REVIEW OF NORTH TRALEE FLOOD STUDIES

FINAL REPORT

Project Review of North Tralee Flood Studies		Project Number 115070	
Client Queanbeyan City Council		Client's Representative Beate Jansen	
Authors Zac Richards Stephen Gray		Prepared by 	
Date 1 February 2016		Verified by 	
Revision	Description	Distribution	Date
3			
2	Final Report	Queanbeyan City Council	February 2016
1	Draft Report	Queanbeyan City Council	December 2015

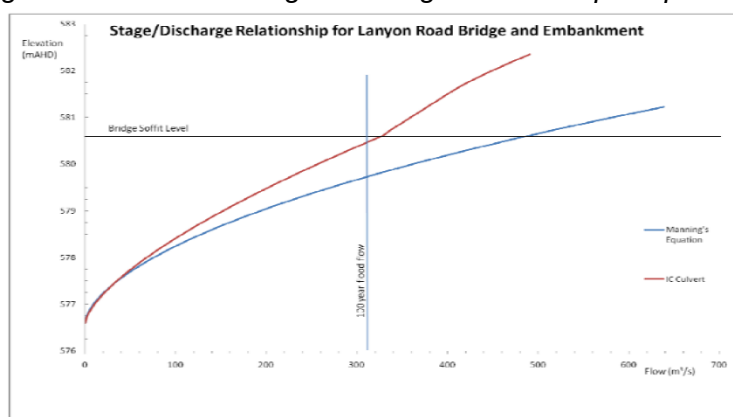
Additionally, no detail has been given about a 'second break' in the railway embankment mentioned in the Brown Study (2010) which is located approximately 200 metres south of the bridge. This structure is modelled in 1D as two 5 m wide non-enclosed flow paths through the Railway. The URS Study (2003) provides details of this structure (see Section 2.2) which are in conflict with that modelled as part of the Brown Study (2010) which would over estimate flow conveyance through this structure.

Due to the importance of these structures on flood behaviour, it is recommended that detailed survey be undertaken for the bridge, the railway embankment crest level within the flood extent, and for the southern 'break in the railway'. The railway embankment has been modelled as overtopped in various locations, the occurrence of which could significantly impact on upstream flood levels.
